EN 1991-1-5:2003/AC

Eurocode 1: Actions on structures - Part 1-5: General actions - Thermal actions

Ref. No.: EN 1991-1-5:2003/AC:2009 D/E/F

Page 21, 'Figure 6.1', delete the figure and replace with the following:

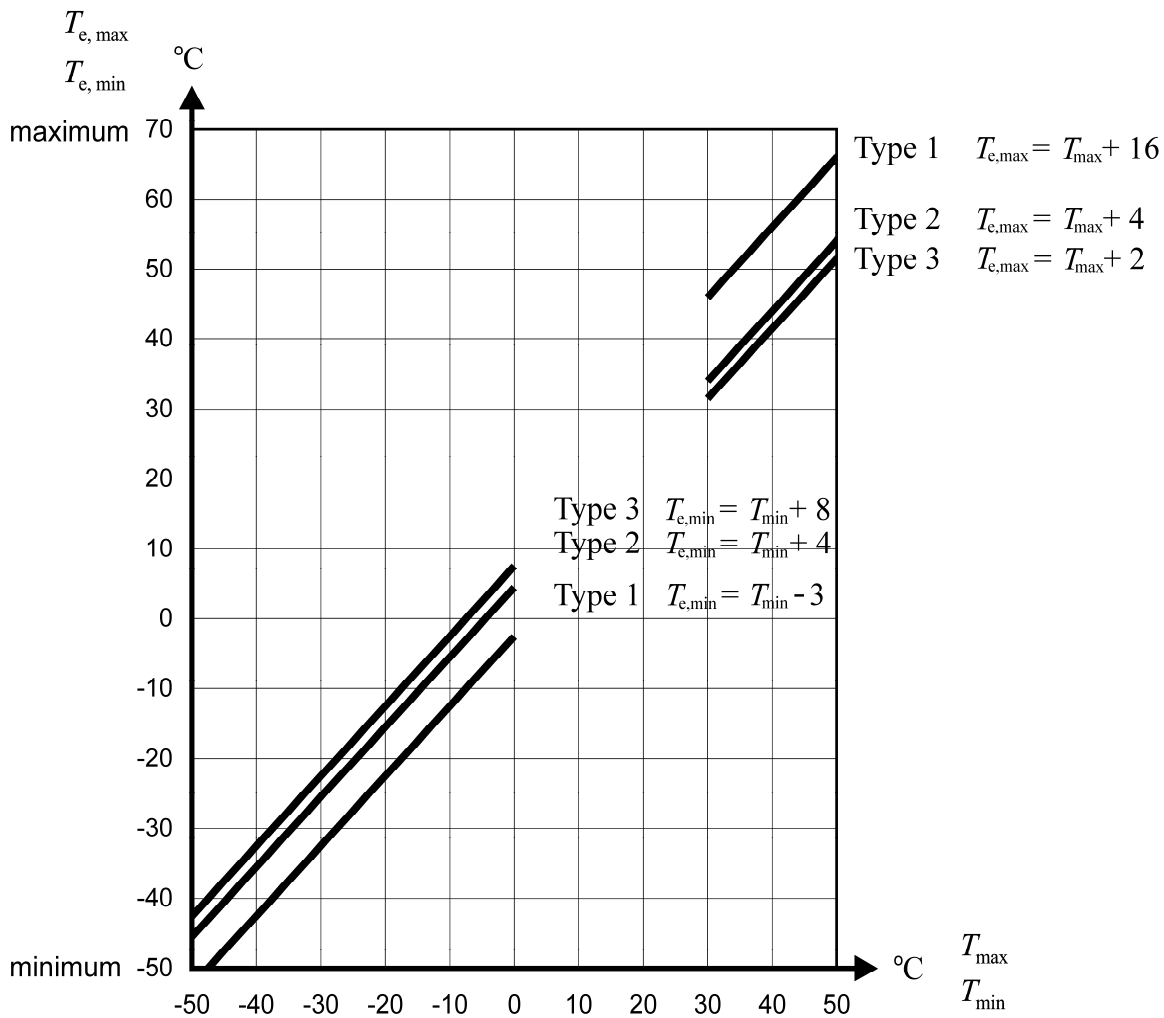
2 Modification to 6.1.3.1, 'General'

Figure 6.2b: Temperature differences for bridge decks – Type 2 : Composite Decks

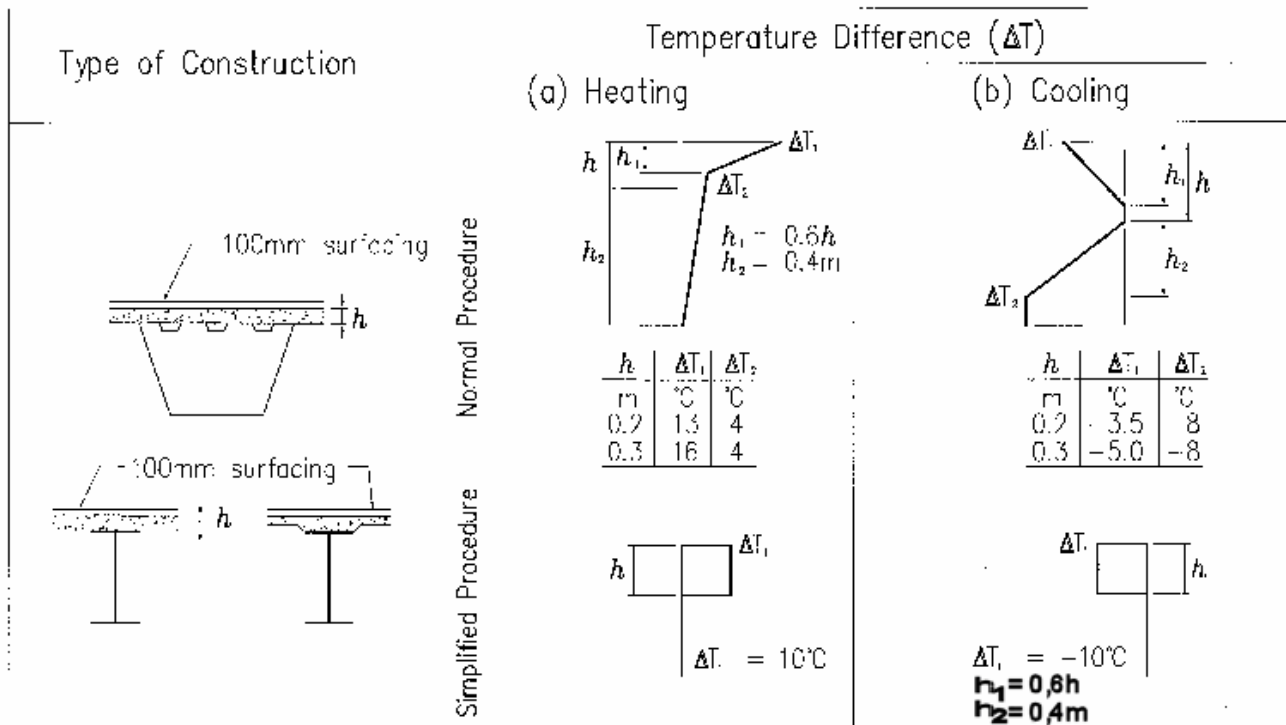
Page 28, 'Figure 6.2b)', replace this figure with the following one:

2. Concrete deck on steel box, truss or plate girders

Note: For composite bridges the simplified procedure given above may be used, giving upper bound thermal effects. Values for ΔT in this procedure are indicative and may be used unless specific values are given in the National Annex

*Note: The temperature difference ΔT incorporates ΔT_1 and ΔT_2 (see 4.3) together with a small part of component ΔT_u ; this latter part has been included in the uniform bridge temperature component (see 6.1.3).
